SERVICE BULLETIN

ENGINE - GENERAL - PROVIDE VARIOUS REPLACEMENT EXTERNAL TUBES WITH RELOCATED TUBE SLEEVES - CATEGORY CODE 7 - MOD.ENG-72-0053

V2500-ENG-72-0053

Clipping point 5523 - Before and after alteration
Fig.8 Sheet 1 of 2

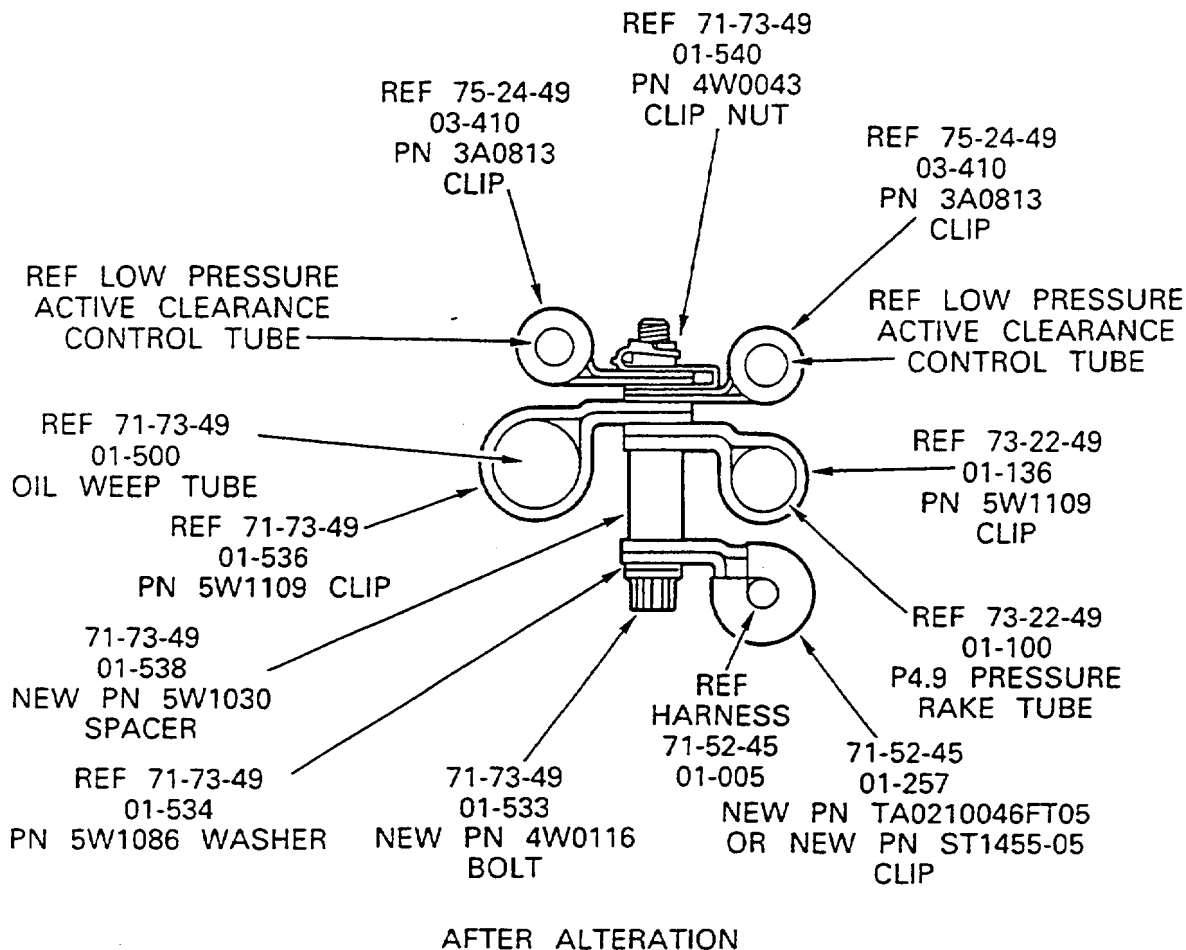
- (d) At CP5523, install 4W0043 clip nut, 3A0813 clips (2 off), 5W1109 clips (2 off), new 5W1030 spacer, new ST1455-05 or TA0210046FT05 clip, 5W1086 washer and new 4W0116 bolt, to the LPT ACC tubes, the oil weep tube, the P4.9 pressure rake tube and the EGT harness. Refer to Figure 8.

New clipping point 6050 - After alteration
Fig.10

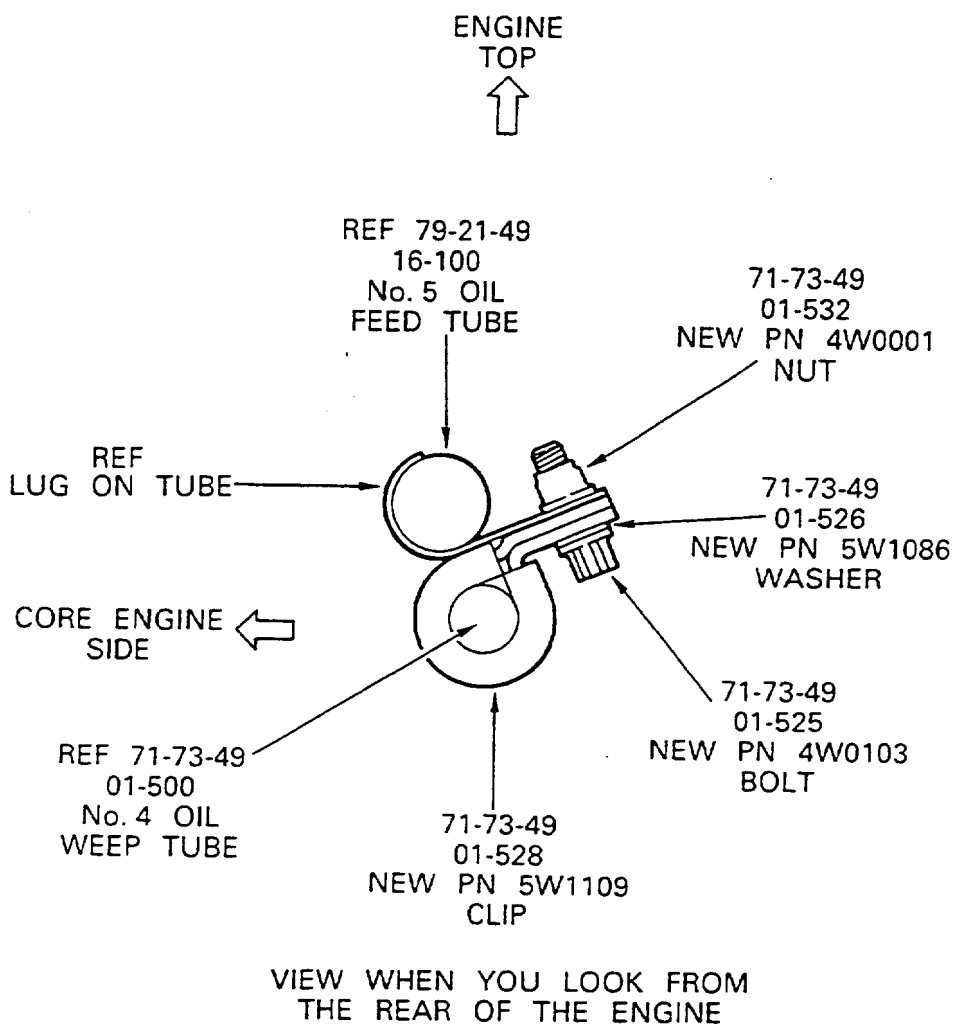
- (i) At CP5206, install 5W1110 clip, 4W0043 nut, 5W1086 washer and new 4W0102 bolt to the bracket and the No.5 oil feed tube. Refer to Figure 7.
- (j) At new CP6050, install new 5W1109 clip, new 4W0001 nut, new 5W1086 washer and new 4W0103 bolt to the lug on the No.5 oil feed tube and the No.4 oil weep tube. Refer to Figure 10.

Clipping point 5549 – Before and after alteration
Fig.14 Sheet 1 of 2

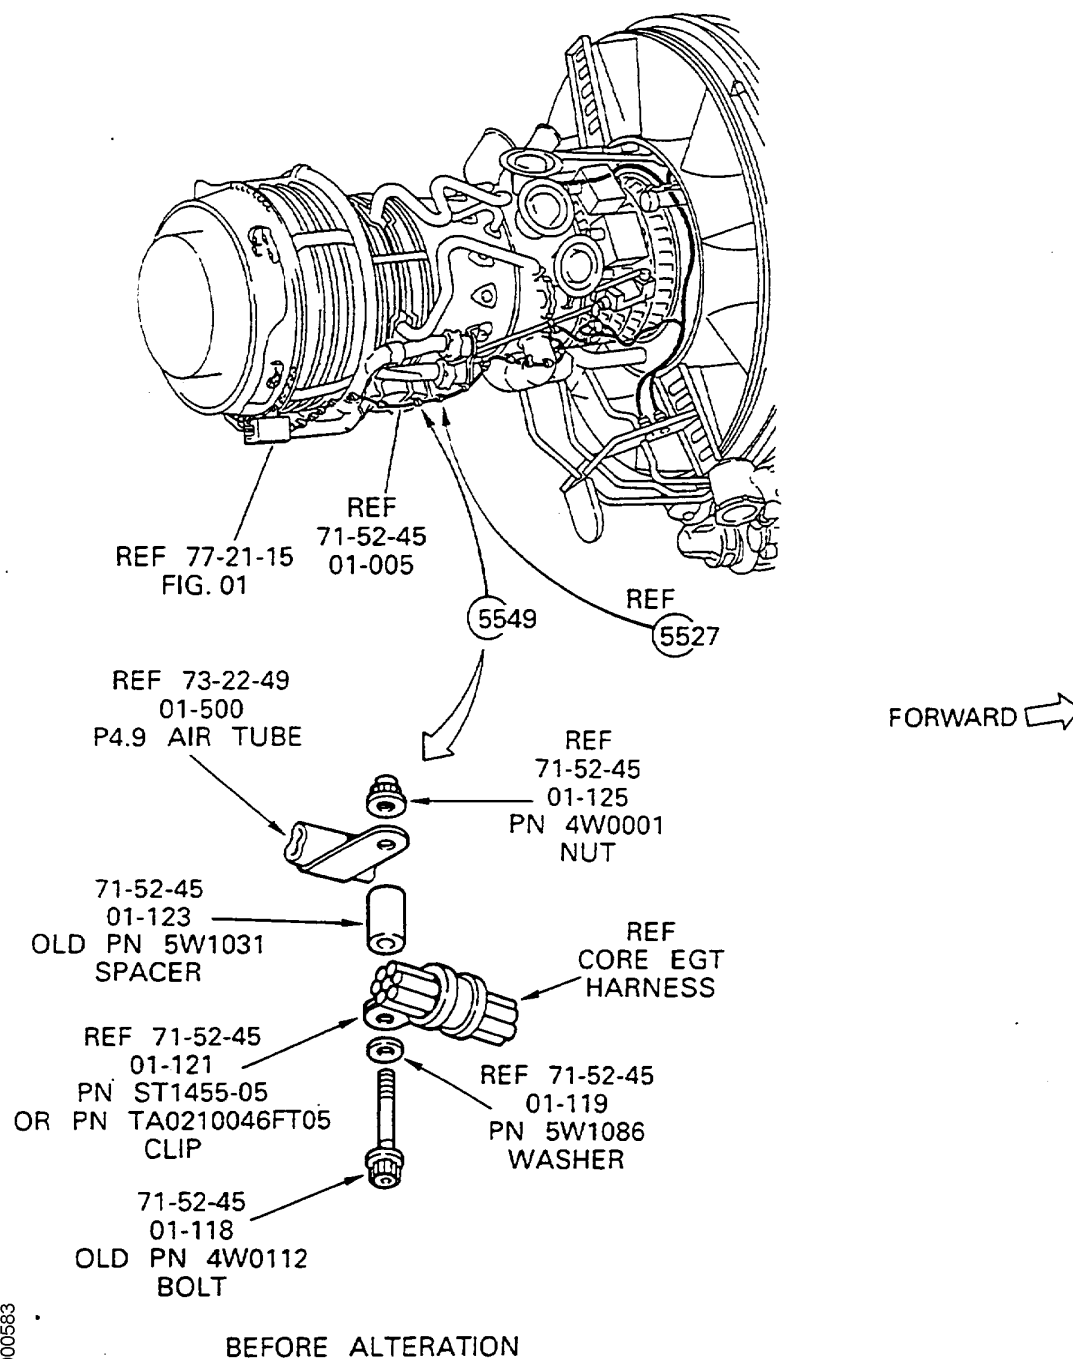
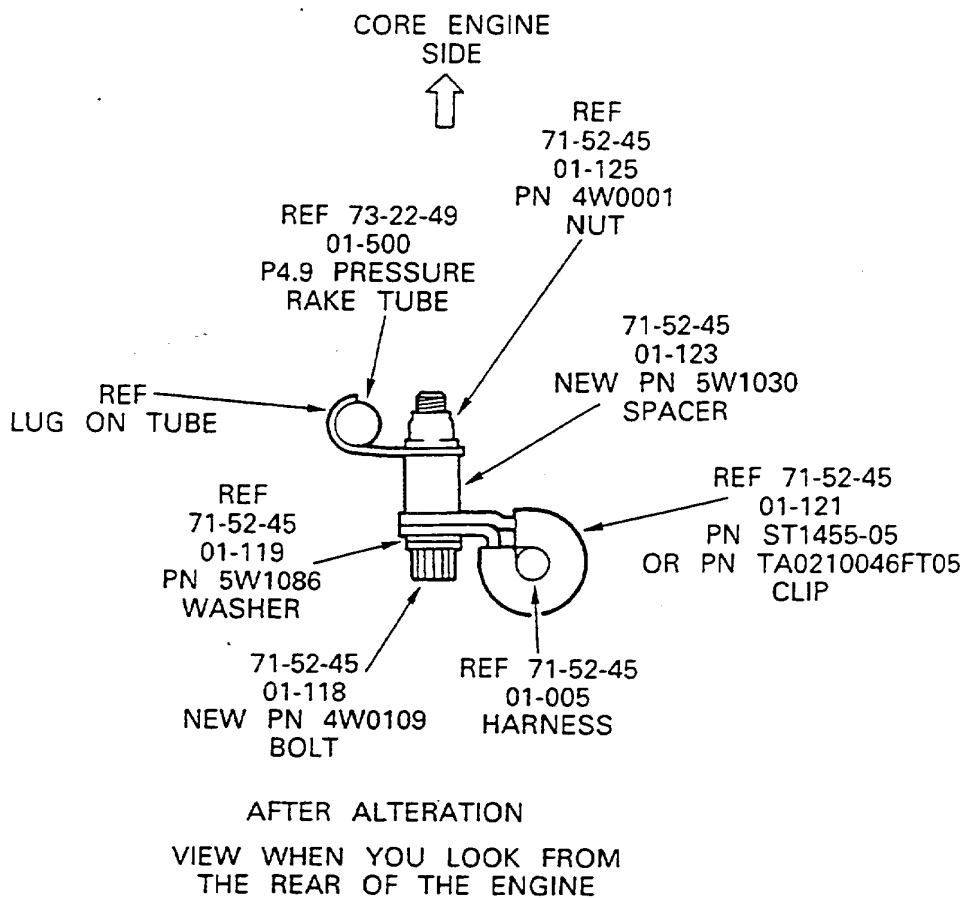
- (h) At CP5549, install 4W0001 nut, new 5W1030 spacer, ST1455-05 or TA0210046FT05 clip, 5W1086 washer and new 4W0109 bolt to the lug on P4.9 pressure rake tube and the EGT harness. Refer to Figure 14.

Clipping point 5734 - Before and after alteration
Fig.15 Sheet 1 of 2

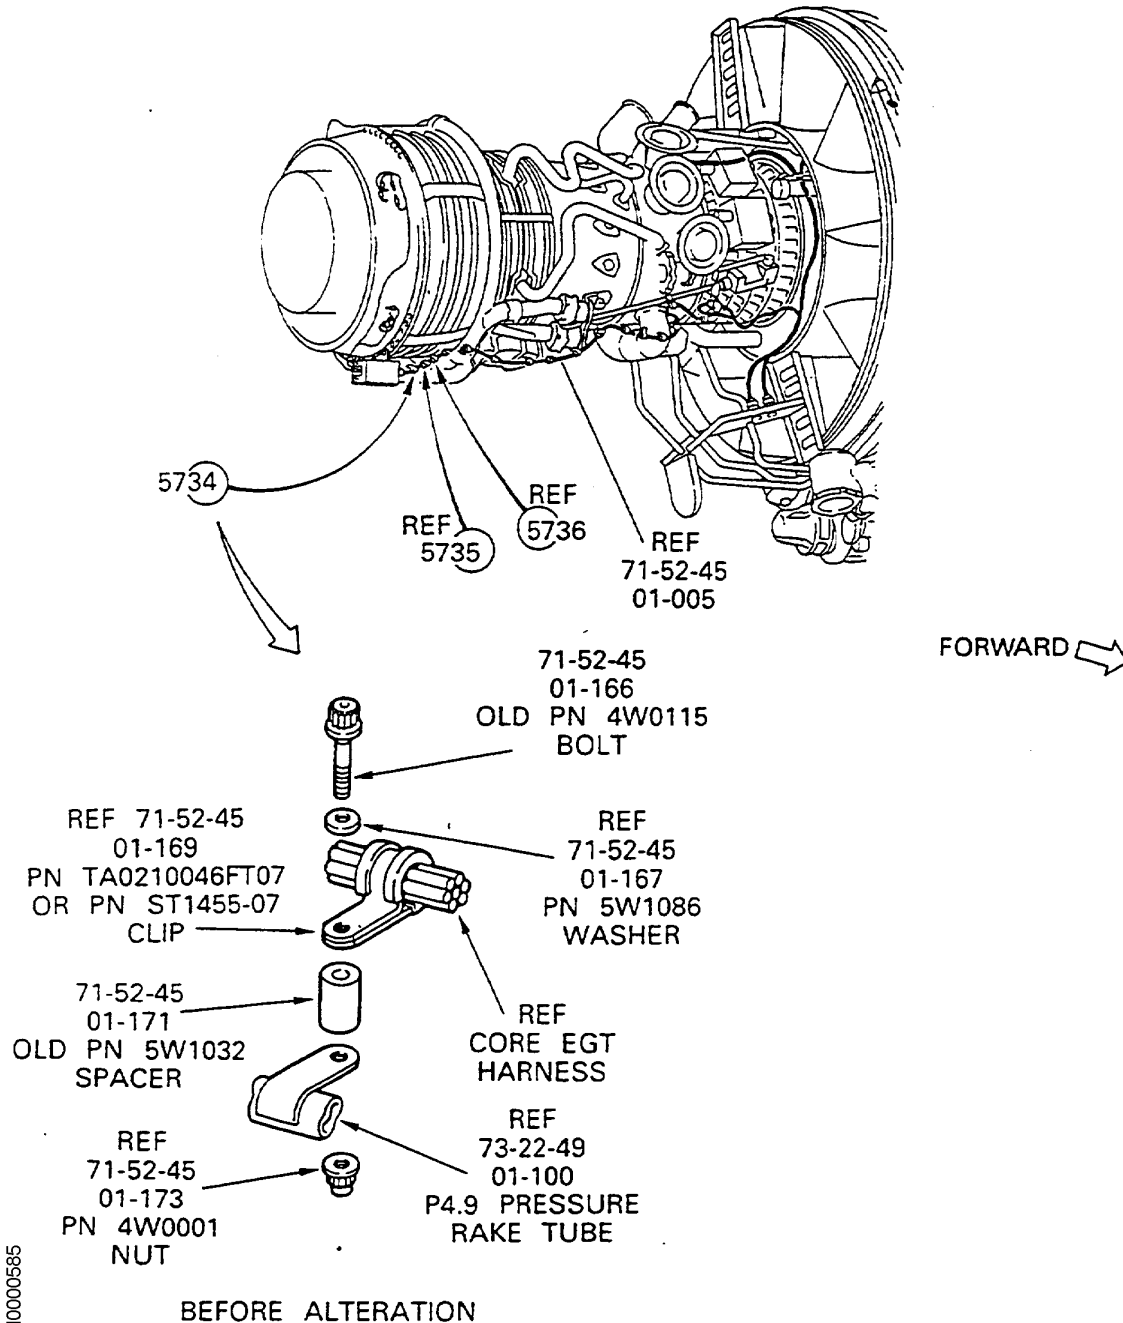
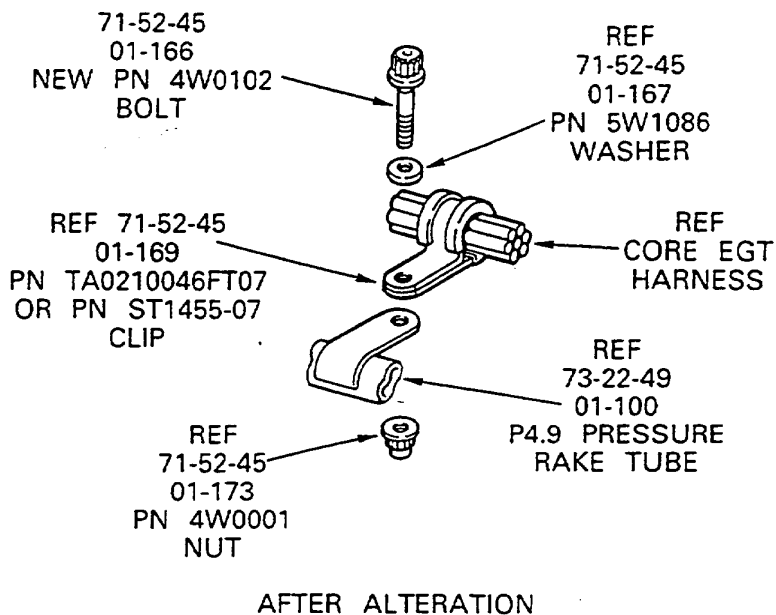
- (b) At CP5734, install 4W0001 nut, ST1455-07 or TA0210046FT07 clip, 5W1086 washer and new 4W0102 bolt, to the lug on P4.9 pressure rake tube and the EGT harness. Refer to Figure 15.

New clipping points 6051 and 6052 - After alteration
Fig.20

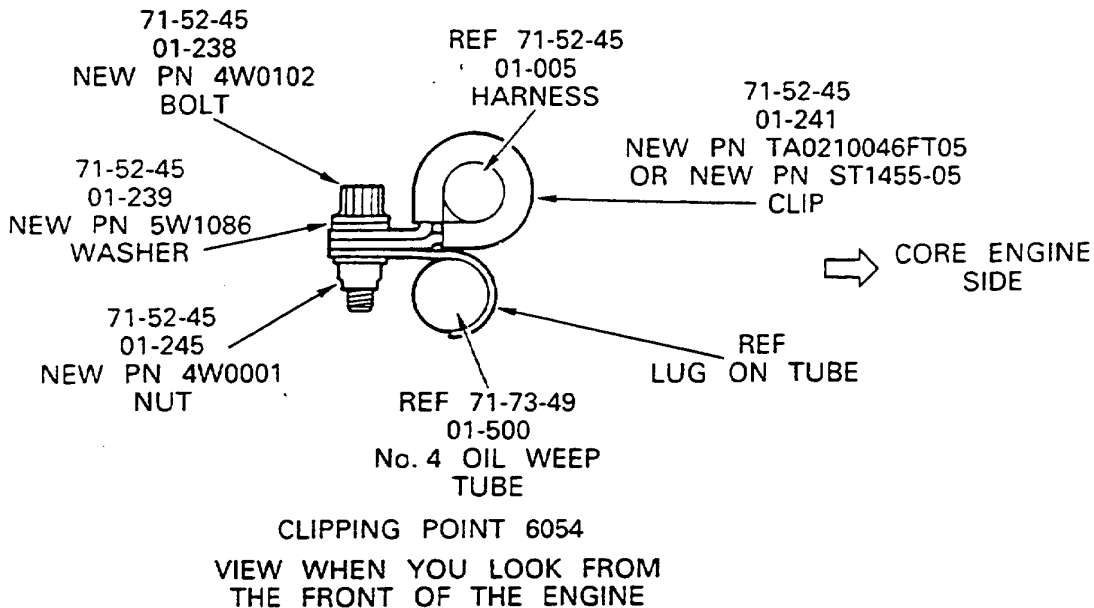
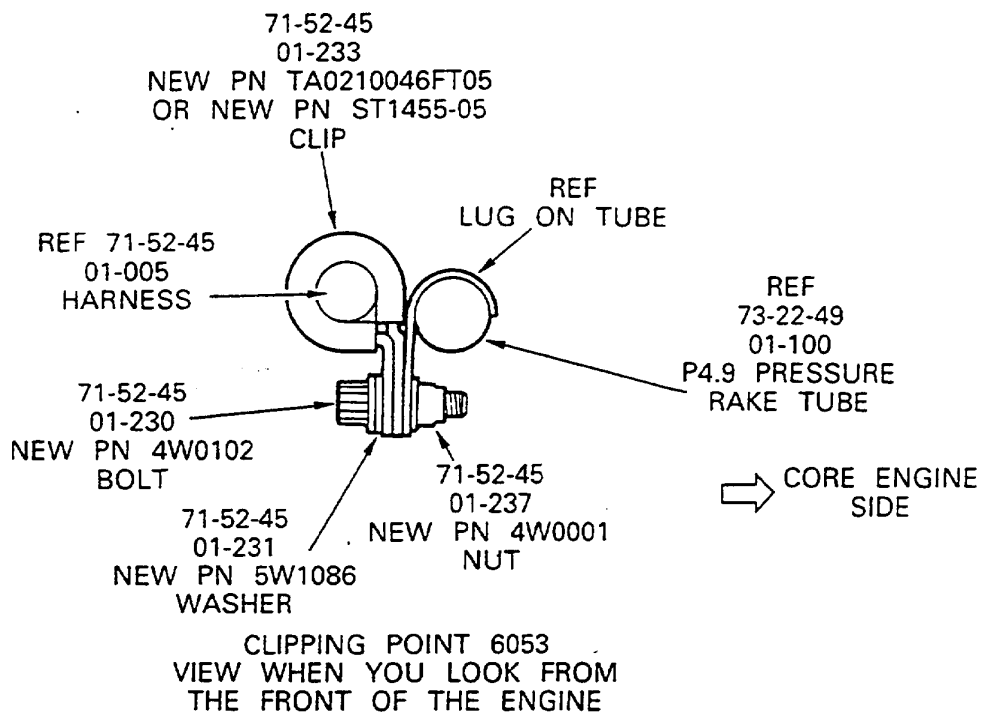
- (f) At new CP6051, install new 4W0001 nut, new 5W1109 clip, 5W1030 spacer, new ST1455-05 or TA0210046FT05 clip, new 5W1086 washer and new 4W0110 bolt, to the lug on oil weep tube, the P4.9 pressure rake tube and the EGT harness. Refer to Figure 20.

- (g) At new CP6052, install new 4W0001 nut, new 5W1031 spacer, new ST1455-05 or TA0210046FT05 clip, new 5W1086 washer and new 4W0112 bolt, to the lug on P4.9 pressure rake tube and the EGT harness. Refer to Figure 20.

New clipping points 6053 and 6054
Fig.21

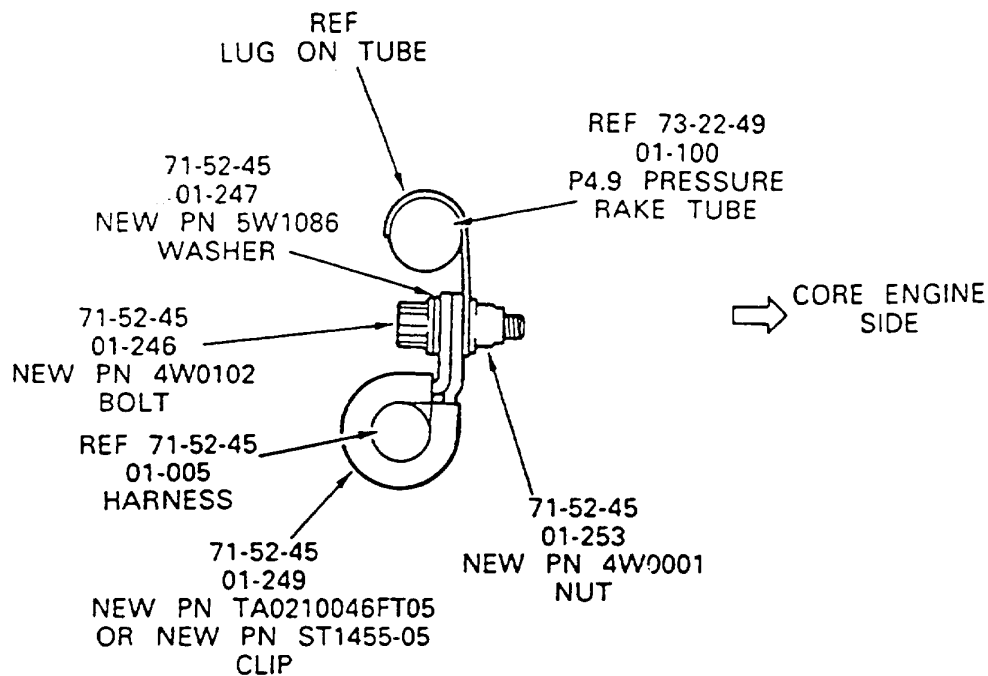
- (e) At new CP6053, install new 4W0001 nut, new ST1455-05 or TA0210046FT05 clip, new 5W1086 washer and new 4W0102 bolt, to the lug on P4.9 pressure rake tube and the EGT harness. Refer to Figure 21.

- (k) At new CP6054, install new 5W1086 washer, new TA0210046FT05 or new ST1455-05 clip, new 4W0001 nut and new 4W0102 bolt to the lug on the No.4 oil weep tube and the harness. Refer to Figure 21.
